MARYLAND DEPARTMENT OF GENERAL SERVICES  
OFFICE OF THE SECRETARY

**TASK ORDER REQUEST FOR PROPOSALS (TORFP)**  
**SHA Statewide Operations Communication Shelter**  
**Solicitation No.: F50B0600044**  
**July 20, 2020**

**QUESTIONS AND RESPONSES #1**

ONELINE DIAGRAM FEEDER#8513\_SHT#3

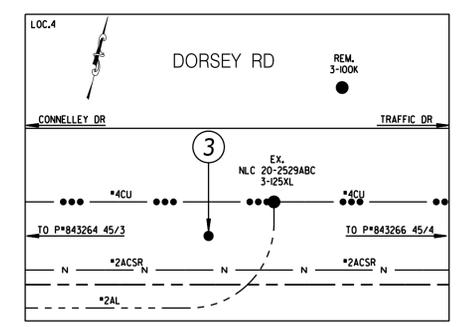
1. Please confirm where the demarcation for the generator natural gas hookup will be. Will the successful bidder be responsible for providing and running the pipe all the way to the BGE connection point, or only to the outside of the shelter? If they will be providing and running the pipe, please provide the location of where they need to install it to.

2. Please confirm that the contractor only needs to run electrical conduit to the marked location of the Utility Frame, and that BGE will be providing and installing conduit from the Utility Frame to their connection point. If that is not the case, please specify what the contractor will need to do.

**Response: Refer to drawing**

**Response: Refer to attached drawing. Contractor responsible for conduit from transformer to utility frame**
